Duquesne Light Company

March 30, 1990

Reference: Beaver Valley Power Station, Unit No. 1 and No. 2
BV Docket No. 50-334, License No. DPR-66
BV-2 Docket No. 50-412, License No. NPF-73
Supplemental Response to Station Blackout Rule -
10CFR50.63

Figure 1
BVPS Unit 1 & 2
AAC Cross-tie

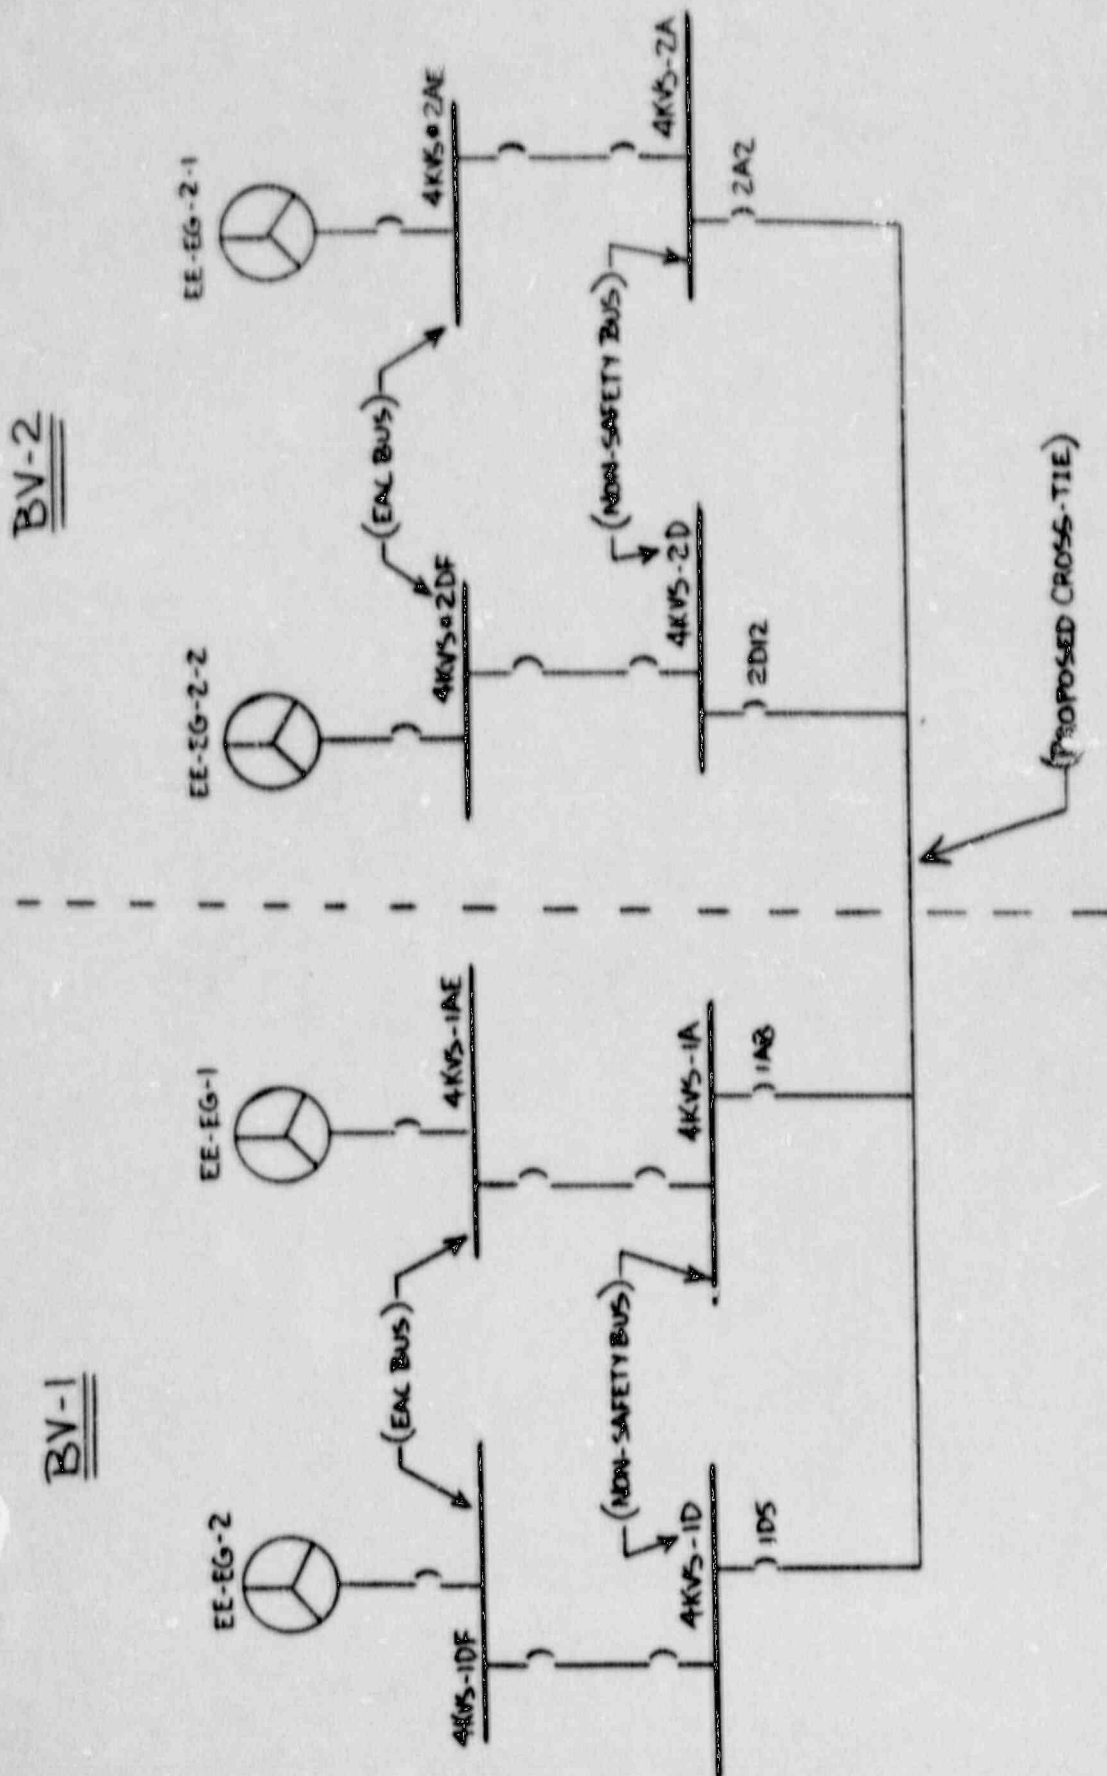
Based on the NUMARC supplemental guidance, our AAC configuration has been revised from our previous submittal (see attached Figure 1). The AAC configuration will utilize a single cross-tie between the Unit 1 and Unit 2 normal 4 KV busses. This change was necessary to meet criterion B.8(e) of NUMARC 87-00 which requires that there be no single point vulnerability whereby a single active failure could disable any portion of the on-site emergency AC power source and simultaneously fail the AAC power source.

The modifications and procedure changes associated with the AAC cross-tie will be completed within two years after the notification provided by the Director, Office of Nuclear Reactor Regulation in accordance with 10CFR50.63(c)(3). Since our Alternate AC (AAC) power source will involve cross-tieing busses between Units 1 and 2, installation and testing will require refueling outages at both units to fully implement the cross-tie capability. Therefore, the schedule for completion may need to be extended, dependent on the NRC approval date and the scheduled refueling outage dates for both Unit 1 and 2. Presently, the schedule for Unit 2's 3rd Refueling Outage is March 1992, and Unit 1's 9th Refueling Outage is September, 1992.
